**REGULAR MEETING OF THE UNITED LAGUNA HILLS MUTUAL
ARCHITECTURAL CONTROL AND STANDARDS COMMITTEE**

Tuesday, November 28, 2017

DATE: November 28, 2017
FOR: Architectural Control and Standards Committee
SUBJECT: Variance Request: Paul S Scottberg, 271-B (Majorca, Plan 9)
Bathroom Remodel

DATE: November 28, 2017
FOR: Architectural Control and Standards Committee
SUBJECT: Variance Request: Jean Maroney of 413-A (Madrid, 4)
Bathroom Addition, Change of Room Use, Window Addition, and
Installation of Resized Window in Living Room

312-C Ave Castilla - Existing floor plan

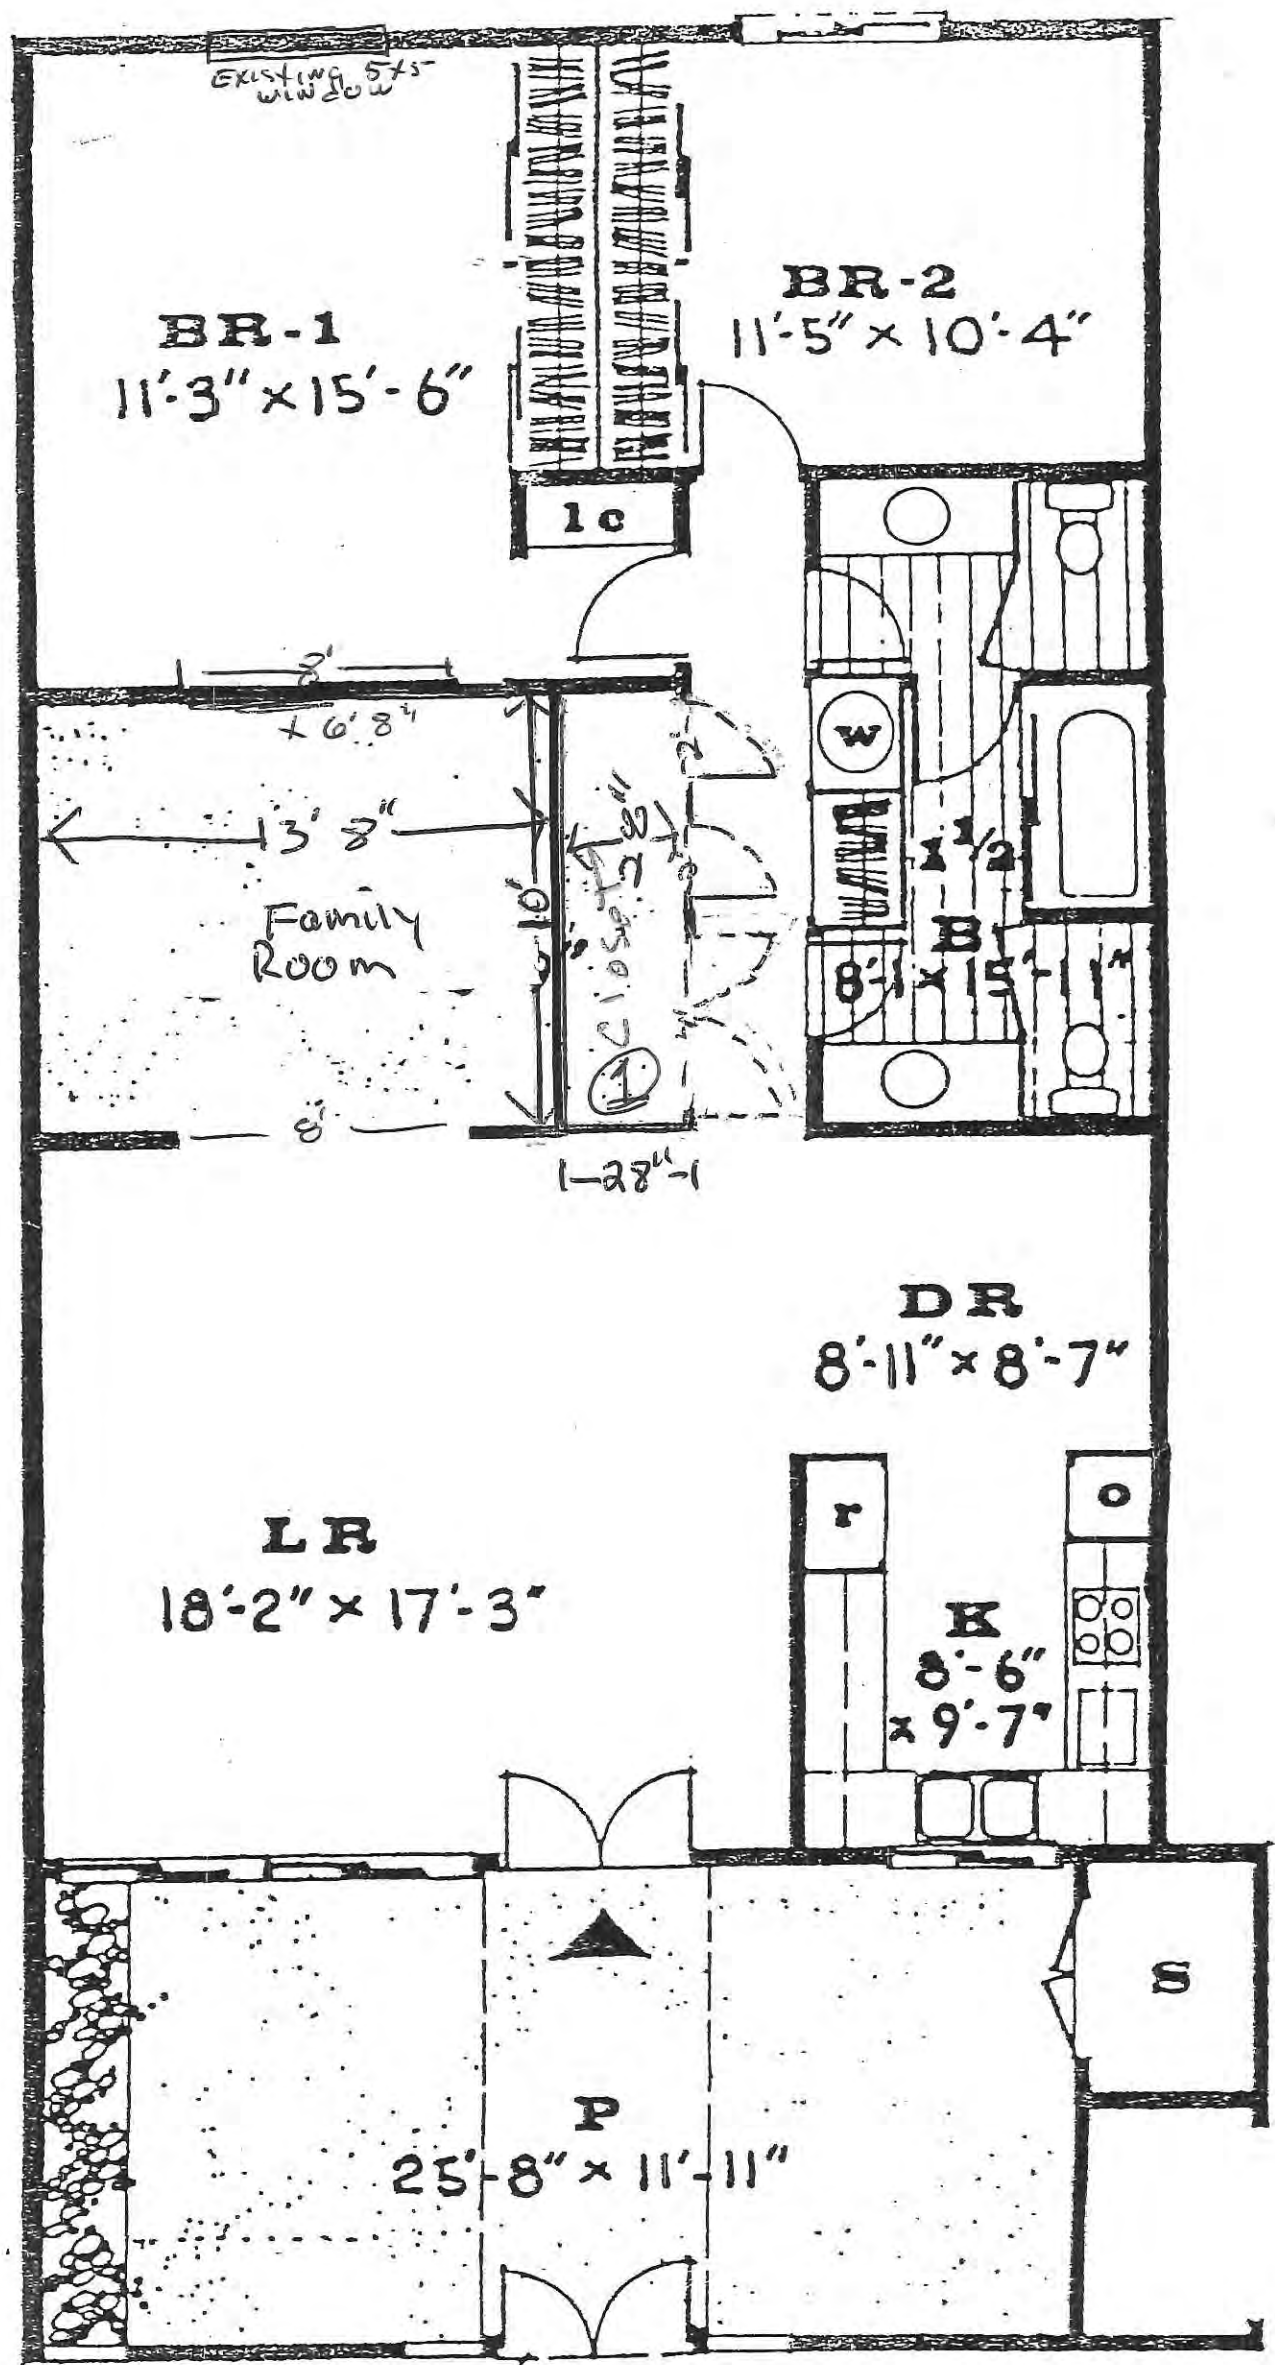
This unit remodel proposes to remove the windows from the existing atrium wall that is adjacent to the bathroom hallway and relocate the wall 28 inches towards the atrium to create new closet space. This would reduce the atrium from 15 feet by 7 inches wide to 13 feet by 8 inches wide. The closet would span the width of the atrium and be approximately 28 inches deep, containing three doors facing the bathroom hallway.

Due to the atrium wall being load bearing, a Condition of Approval has been included that requires a complete set of unit specific plans prepared by a licensed architect or structural engineer depicting the proposed improvement. These plans are to be provided prior to a Mutual Consent being issued by the Manor Alterations Department.

- 1- relocate hall/family room wall back 28" into existing family room ^{using} ~~and~~ space for new closets
- 2- Remove existing 8' wide sliding door and build ~~in~~ ⁱⁿ wall in sliding door place

10. Prior to the issuance of a Mutual Consent for Unit Alterations, a complete set of unit specific plans prepared by a licensed architect or structural engineer depicting the proposed improvement must be submitted to the Division office located in the Laguna Woods Village Community Center. The plans must depict any required structural modifications ensuring the structural integrity of the building is maintained upon completion of the proposed improvement.

DOUGLAS BROUGHTON
557 AVENIDA SEVILLA UNIT P Laguna Woods, Ca
92637

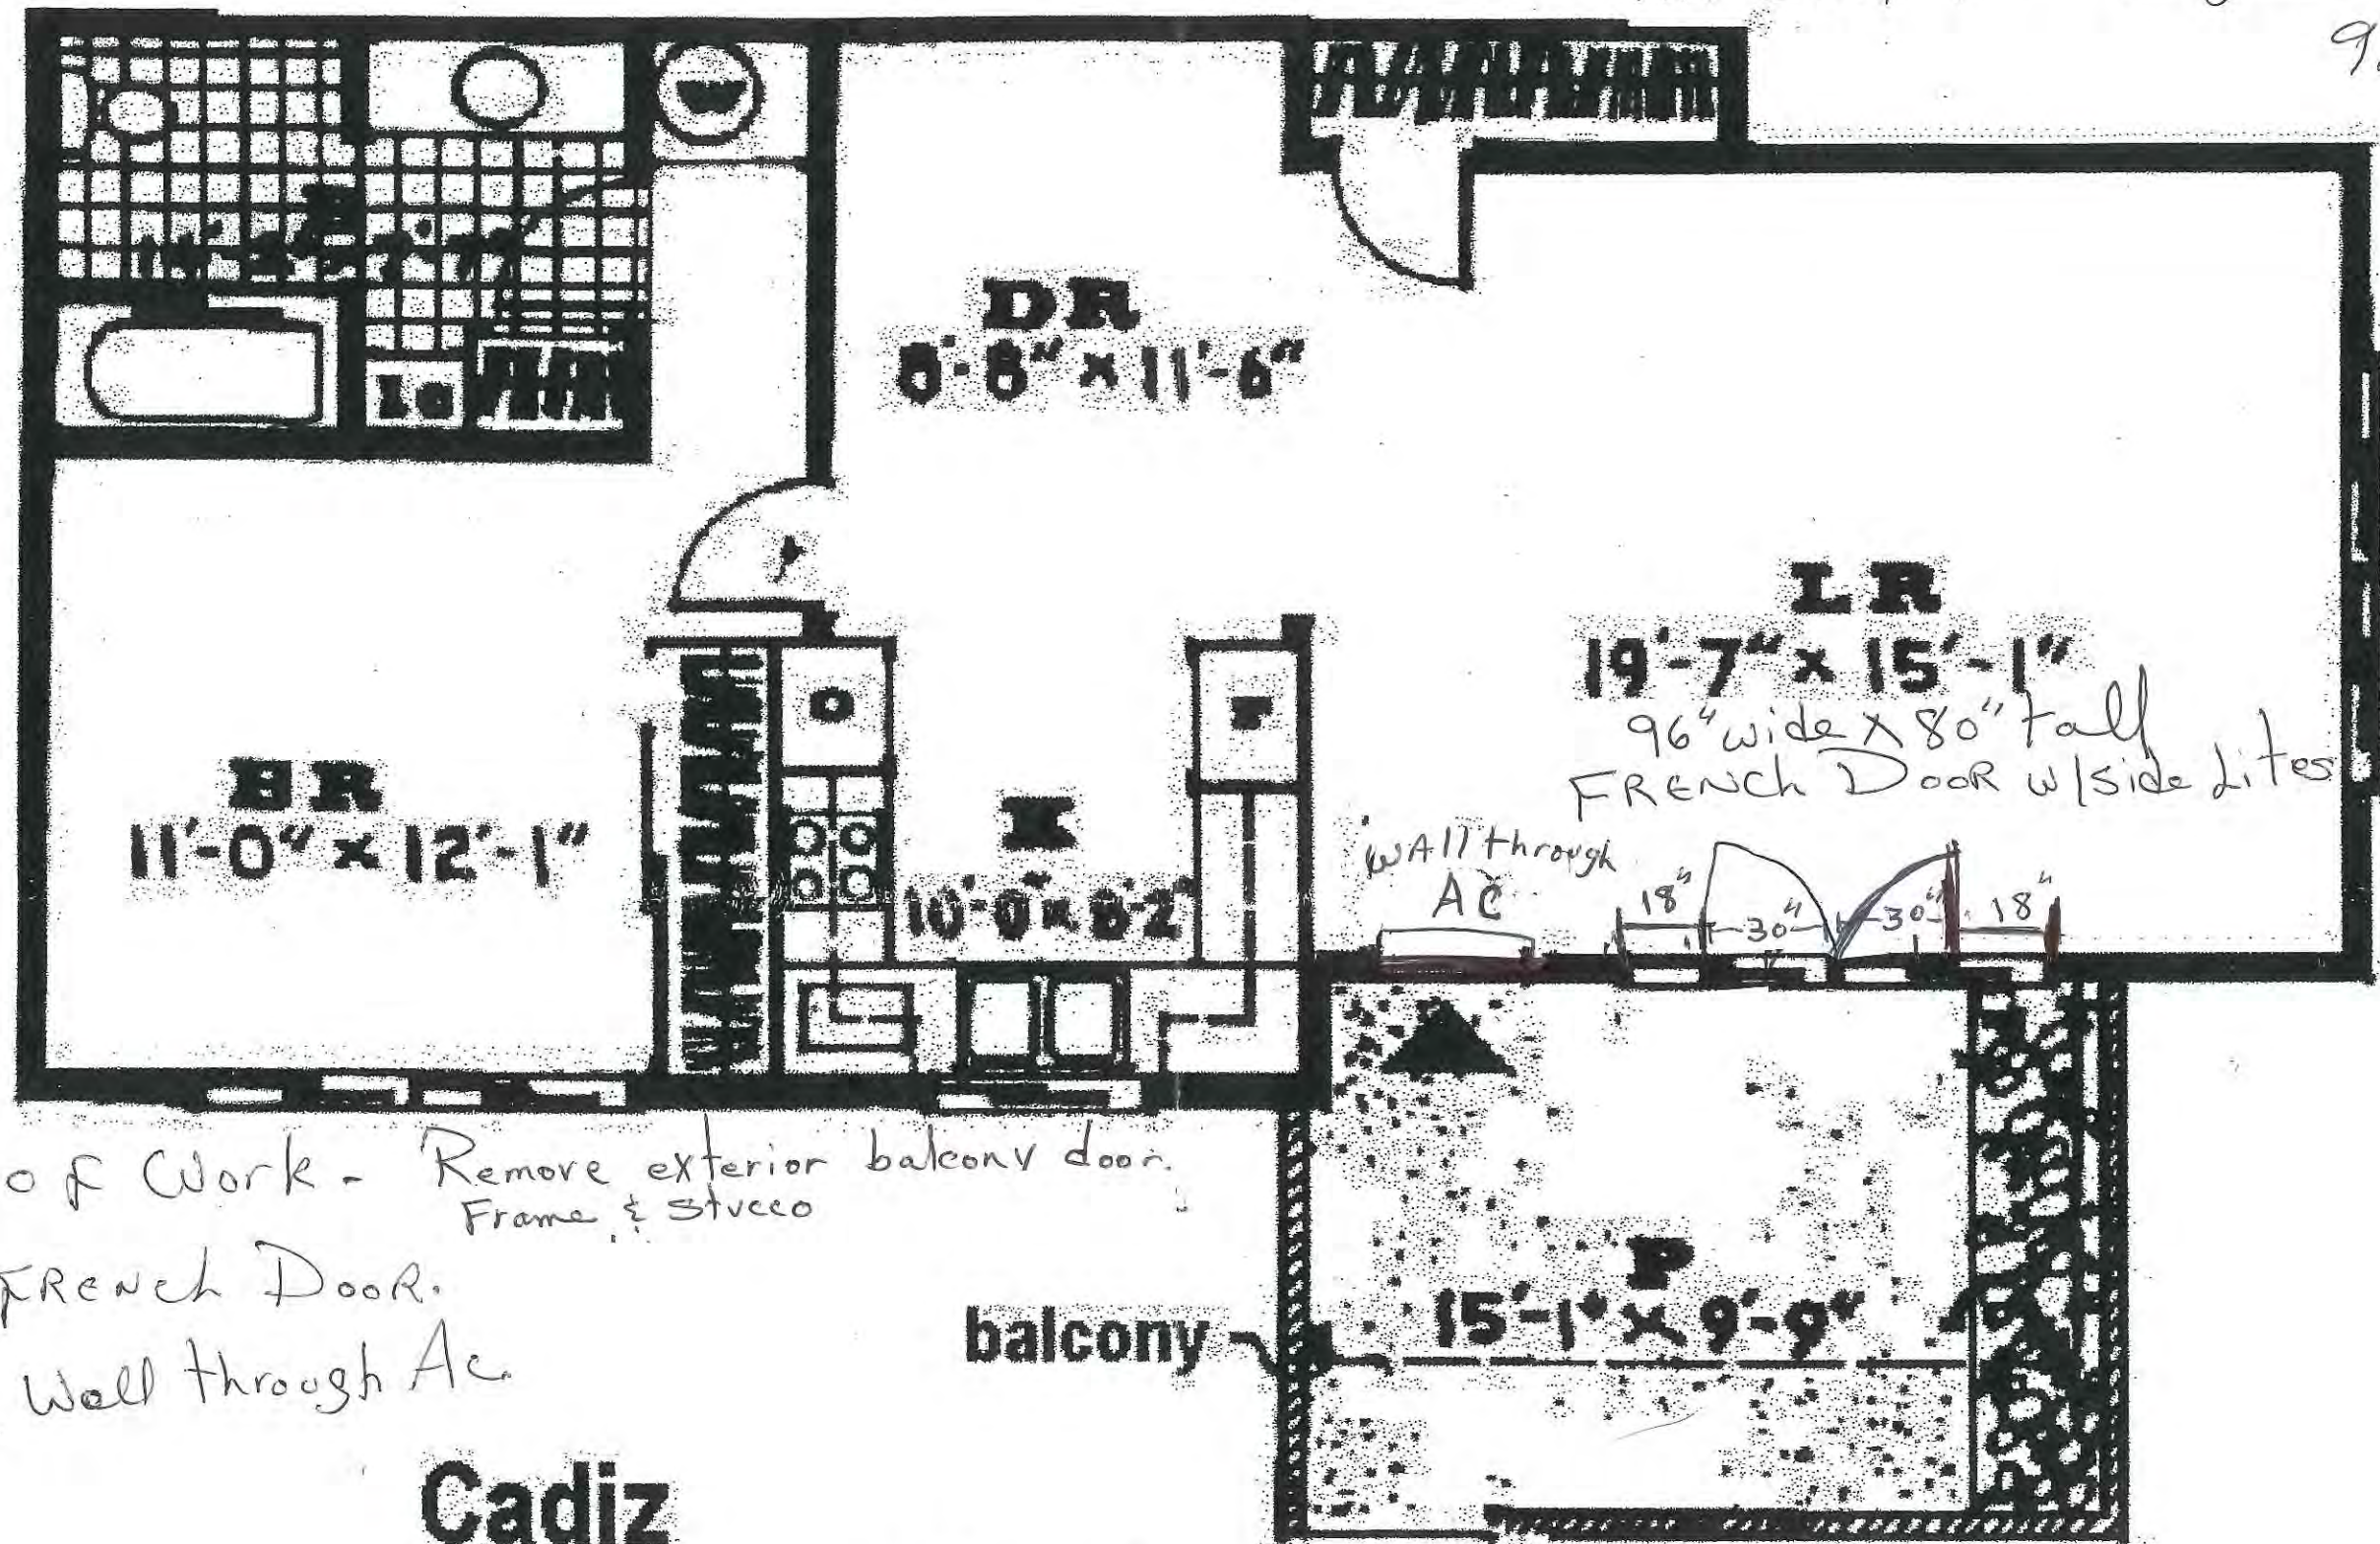
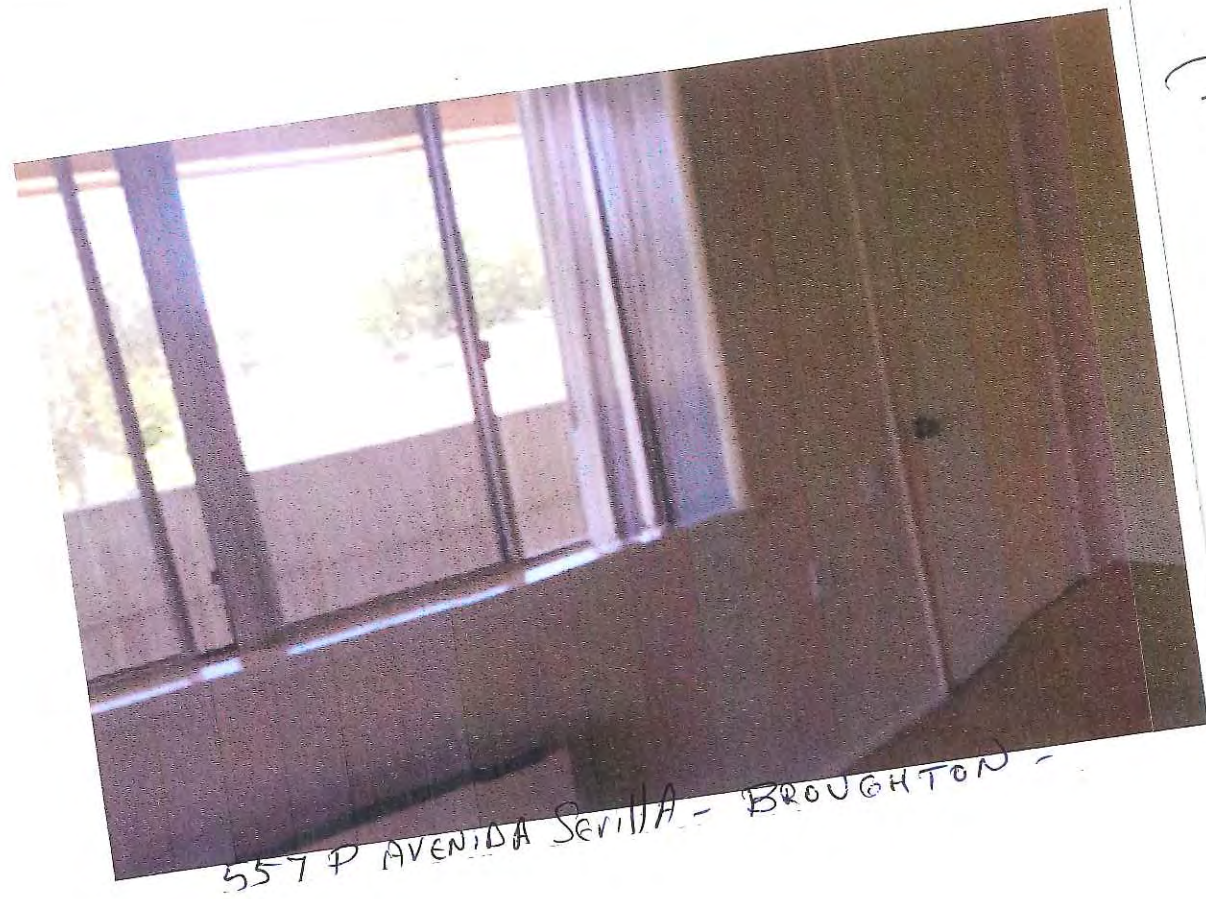
The original floor plan of the Cadiz style unit has a single door which is 36 inches wide by 80 inches high and a large window, 96 inches wide by 47 inches high, leading from the living room to the balcony.

Scope of Work - Remove exterior balcony door.
Frame & Stucco
Installed French Door.
Installed wall through AC.
